**Carlyle/Eisenhower East Design Review Board (DRB)
Application**

PROJECT NAME: Blocks 4+5 Hoffman Town Center BLOCK: 4+5

Carlyle Design Review Board
Submission-July 18, 2019 Hearing
2410 & 2460 Mill Road
HTC Block 4 & 5
19-0007

RE: Hoffman Town Center, Blocks 4 & 5
DSUP #2019-0018
Comment Response Letter
Cooper Carry project# : 20160037

APPROVED DSUP
12/19/2017

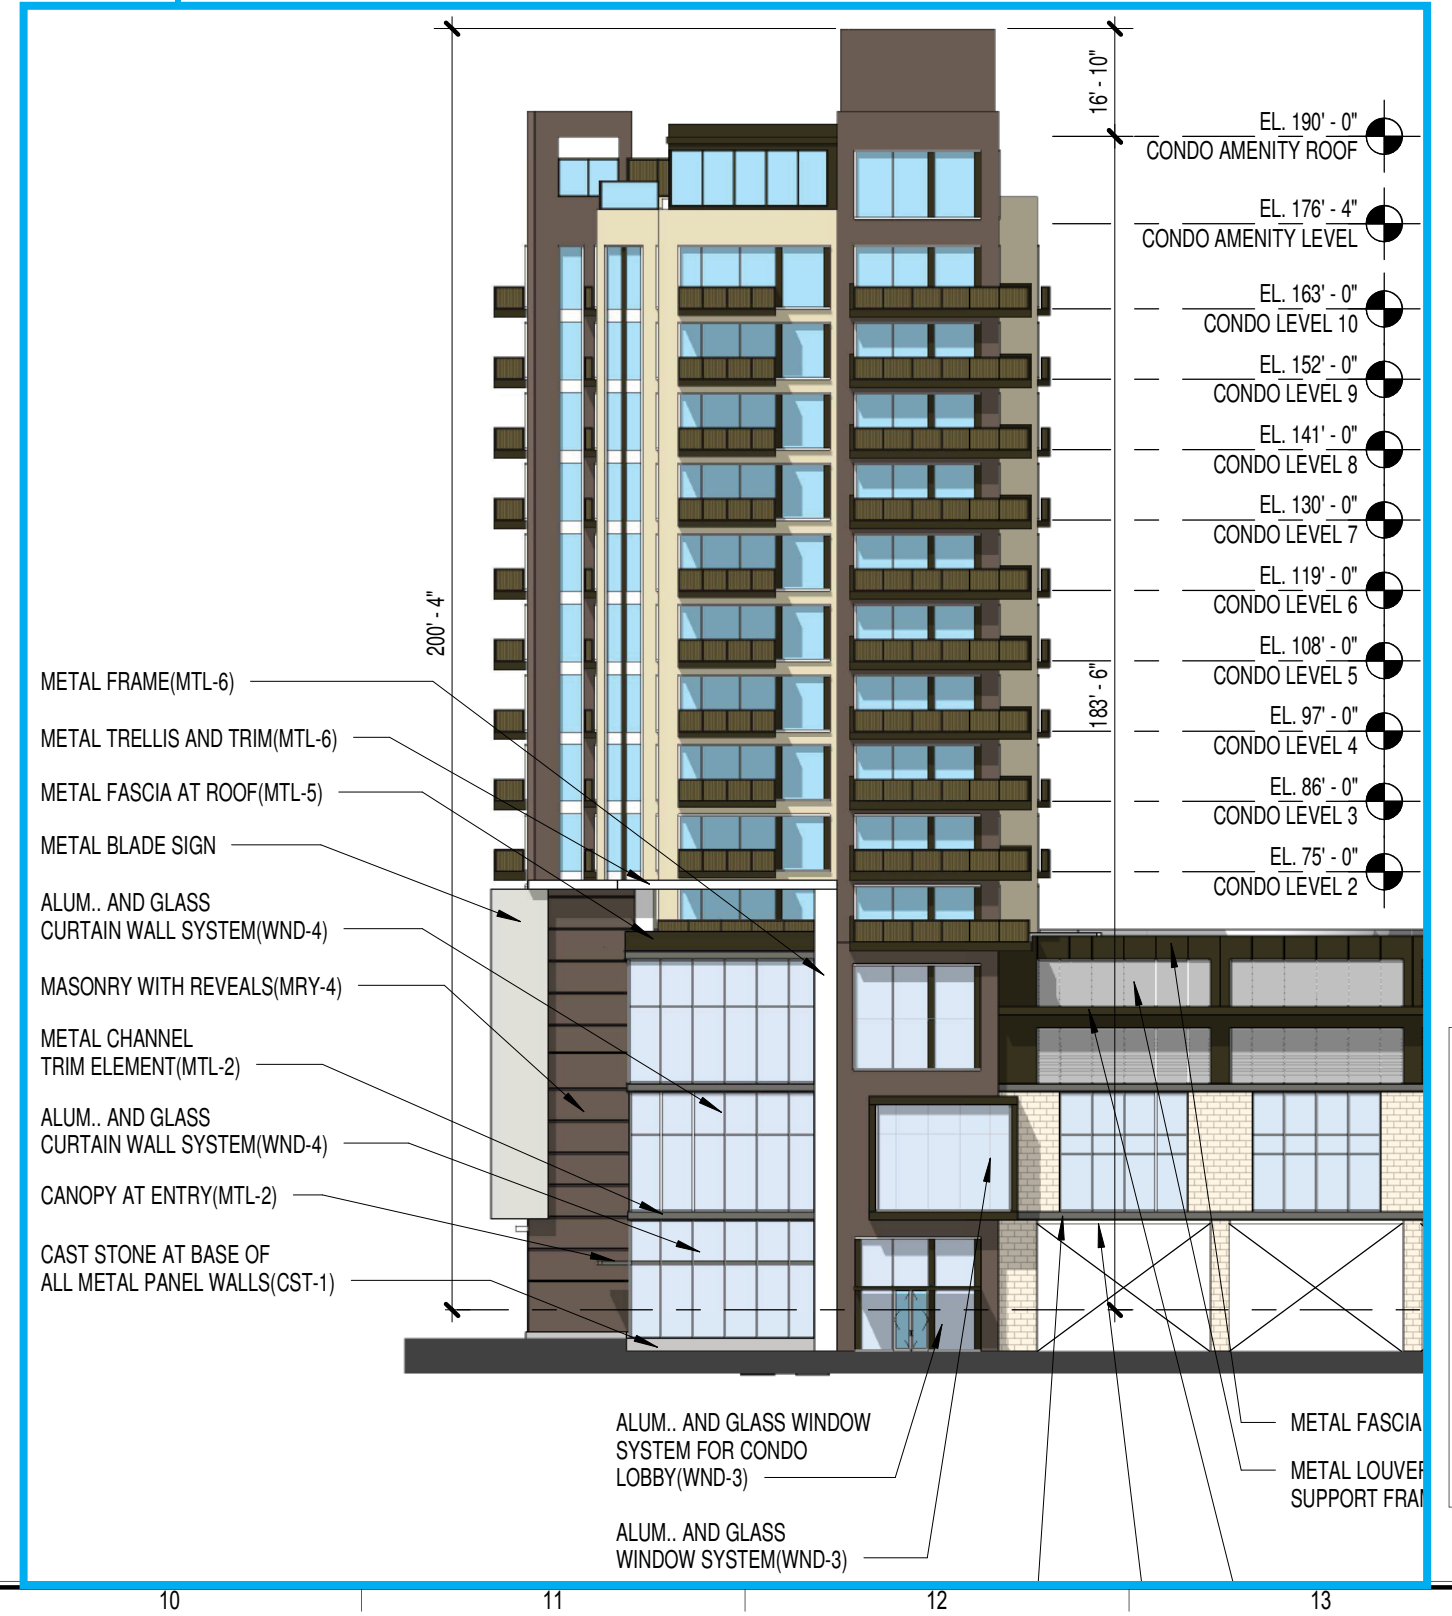
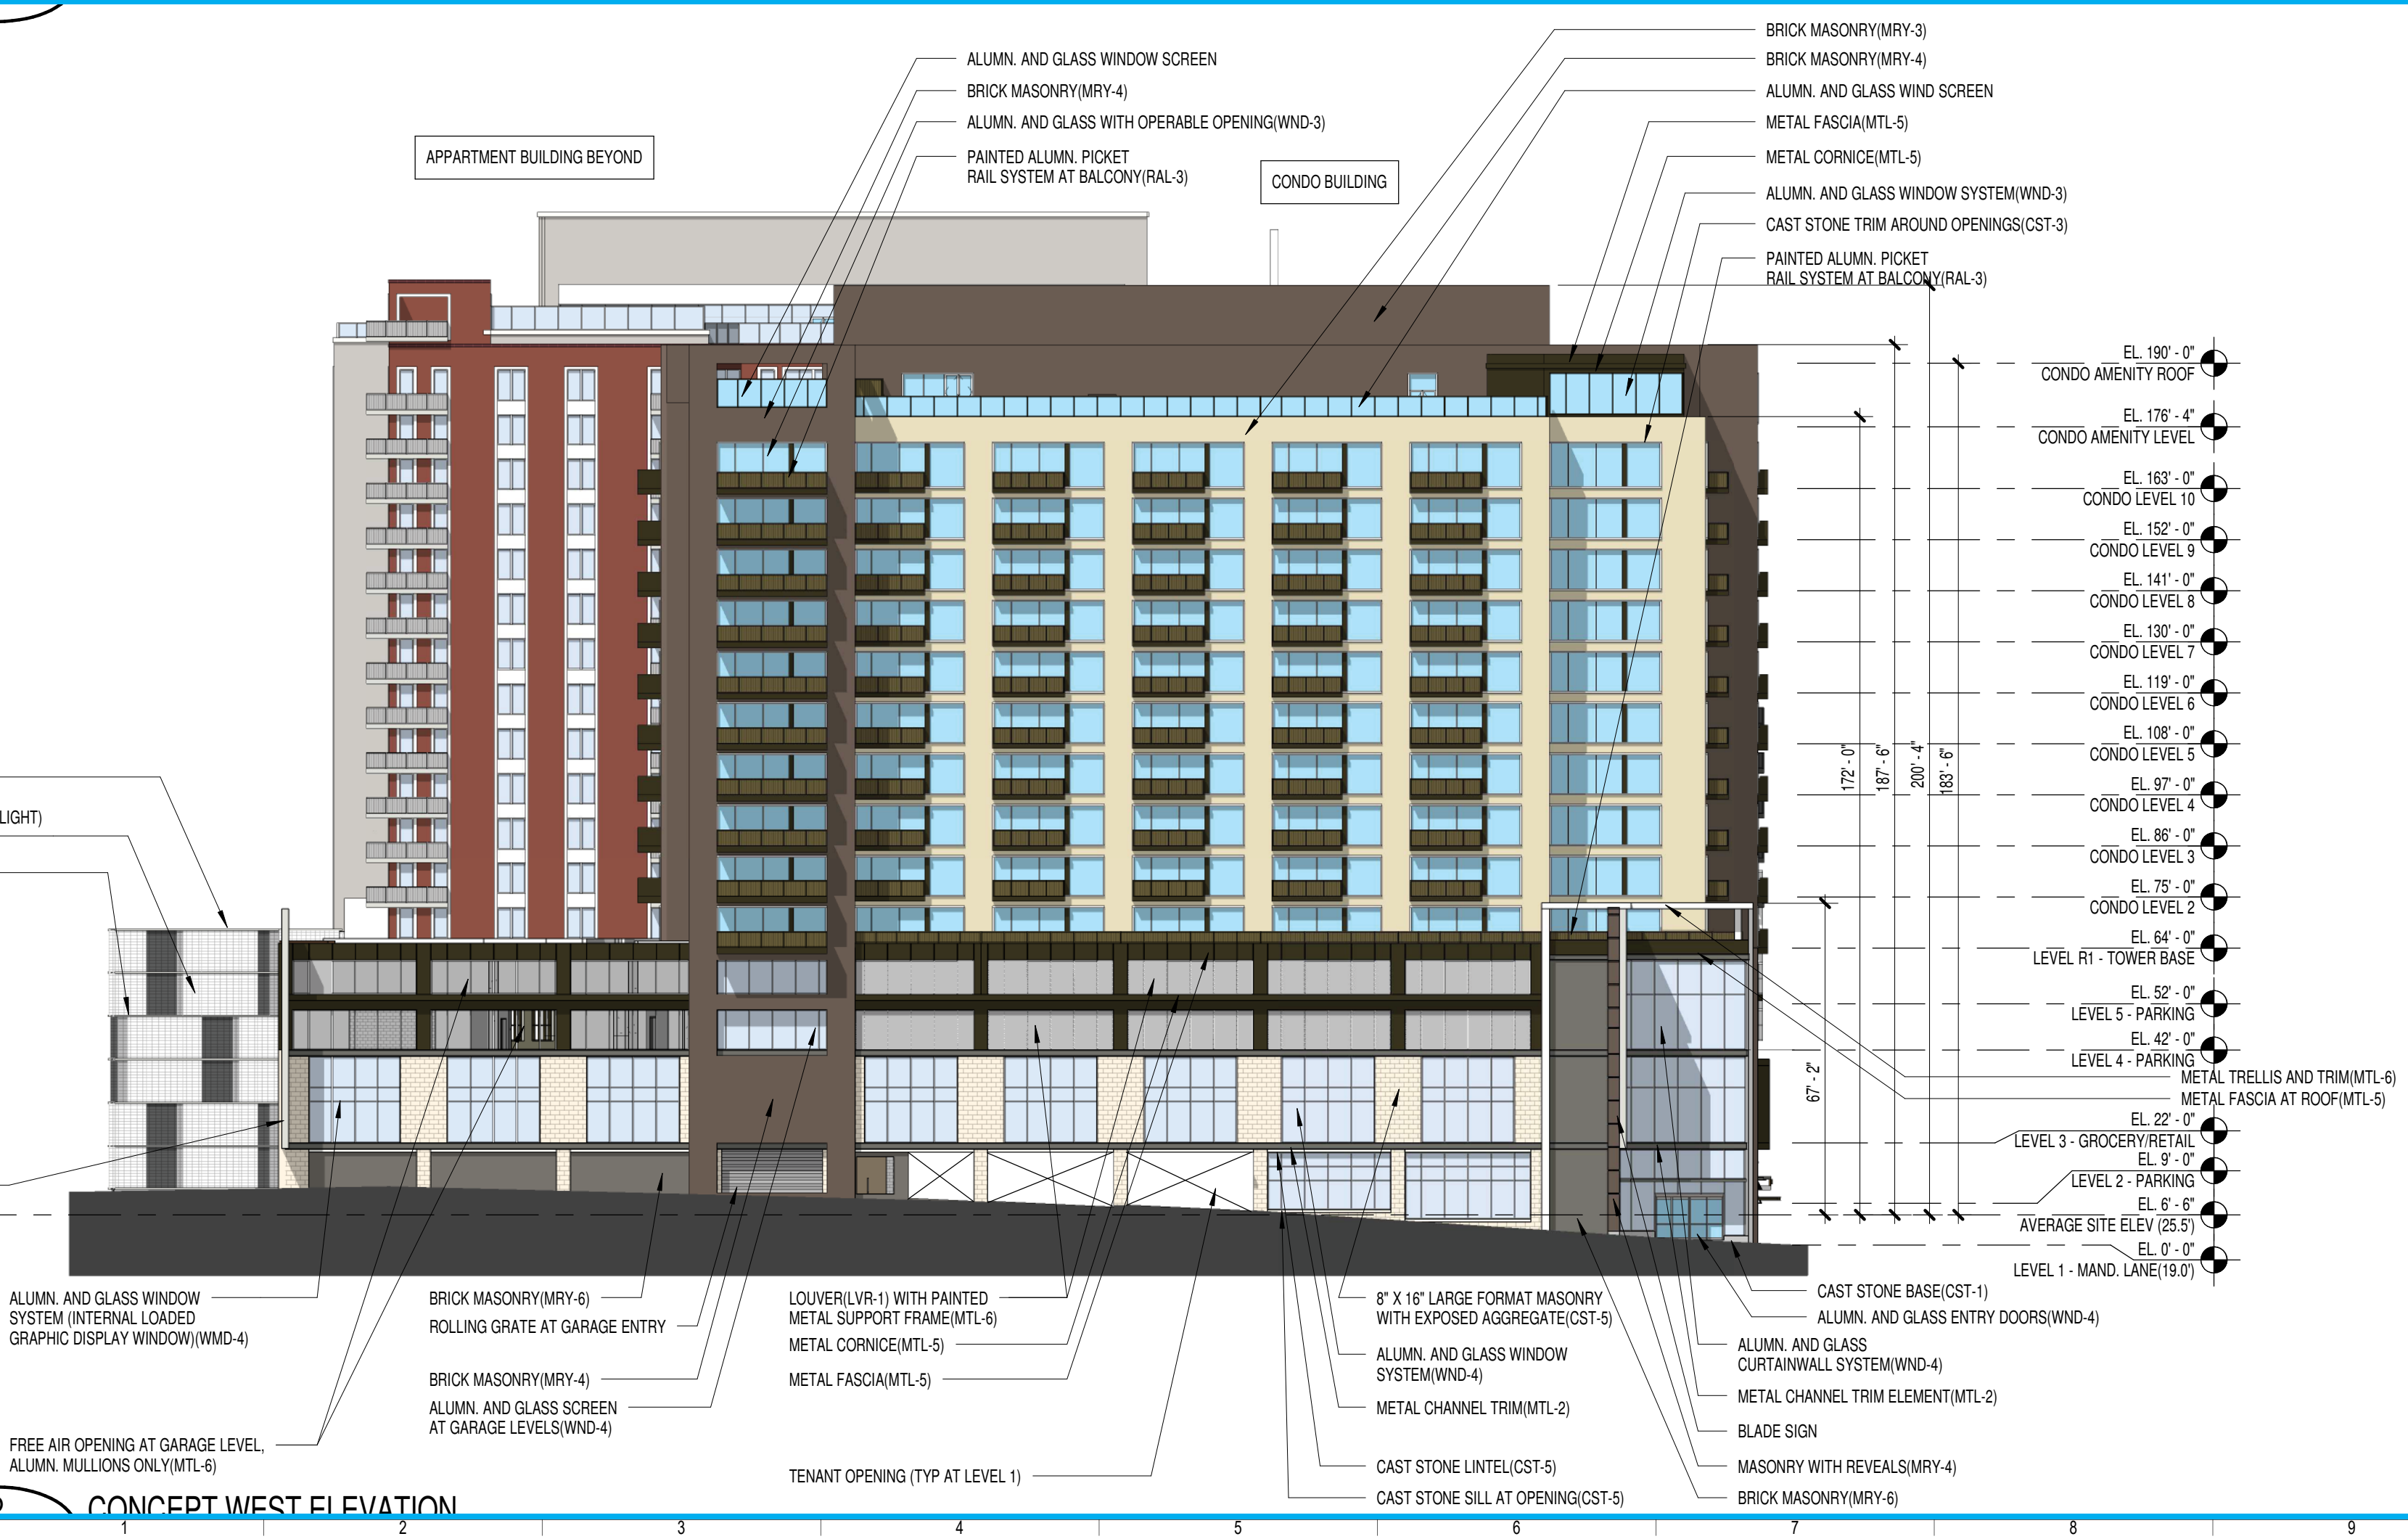
- e. The south end of the amenity level was a previously enclosed form and connected to the south-facing vertical accent as enclosed space. It is now a free-standing fin and appears much thinner than the corresponding one that faces west.

- f. The heavy return on the south face of the brown vertical accent negates the approved expression of the building element as a “thick wall” which projects well above and out from the primary building volume.

- d. Two entire vertical columns of south-facing windows have been deleted from the face of both the west brown vertical accent, and the south return face of the cream-colored central portion, creating two blank walls where there was corner glass.

- a. Major portion of the upper penthouse (approx.. 13' high x 153' long) previously aligned with the distinctive center features on both the west and east elevations and has been eliminated. Results in a longer, undifferentiated penthouse. (west elevation)

Response: The south end of the amenity level has been revised to be an open volume. It has been given the language of the “basket handle” to match that of the west and northeast elements.

Response: The south face of this accent has been modified with the footprint change in the DSUP amendment. It now recesses into the volume accentuating the 2'-8" “thick wall” as it carries down to grade. To articulate what otherwise would be a blank wall on this elevation, further texture has been added to this wall by adding reveals which align to the datum of window sills and headers.

Response: The vertical column of windows in the cream-colored brick has been restored. The column of windows in the brown vertical accent has not been returned due to conflicts with the interior unit layout. However, as to not have a blank wall on this elevation, further articulation has been added to this wall by adding reveals which align to the datum of window sills and headers.

Response: The upper penthouse has been elevated to be more consistent with the original architecture. It now stands 10'-0" high x 187'-0" long.
